UNITED STATES OF AMERICA
NUCLEAR REGULATORY COMMISSION

This amendment application consists of Proposed Change NPF-10-263
to Facility Operating License No. NPF-10. Proposed Change NPF-10-263 is a
request to revise Technical Specification 3/4.1.3.4, "CEA Drop Time." The
proposed change will increase the specified drop time for control element
assemblies from 3.0 to 3.2 seconds.

DESCRIPTION AND SAFETY ANALYSIS
OF PROPOSED CHANGE NPF-10/15-263

This is a request to revise Technical Specification 3/4.1.3.4 "CEA Drop Time."

FIGURE 1

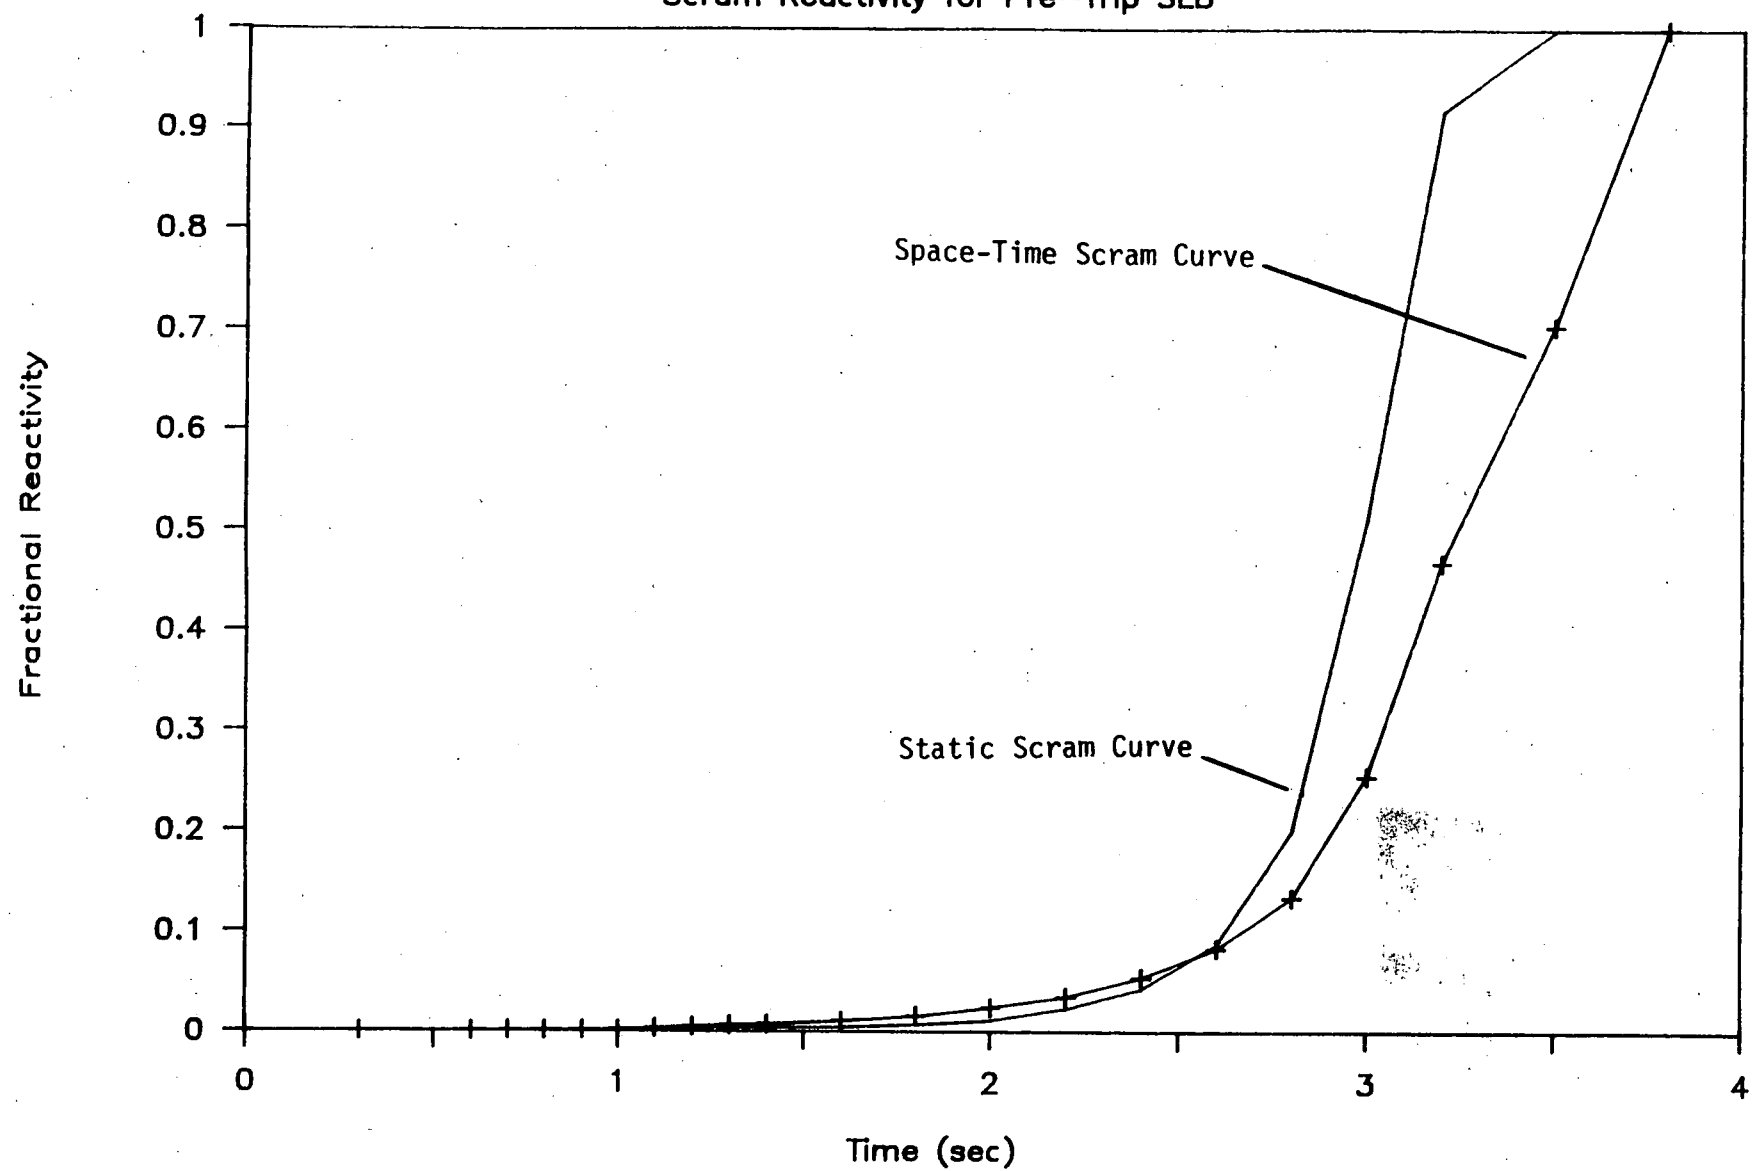
In terms of radiological consequences, the limiting Pre-trip power excursion was the outside containment break location. The minimum DNBR occurs approximately 1.5 seconds after the trip breakers open. The transient was modeled using static scram curves. Figure 1 shows a comparison of the negative reactivity added by the static scram curve used and a space time scram curve with CEA motion delayed by 0.3 seconds. A slight non-conservatism exists prior to 1.0 seconds, but never exceeds 0.003%. By 1.2 seconds, the space time curve is conservative and at the time of minimum DNBR, the delayed space time curve added 0.37% more negative reactivity than the static curve inserted. Near full insertion the revised curve again predicts less negative reactivity insertion but this is well past the point of minimum DNBR. Therefore, the conclusions of this event are unchanged.
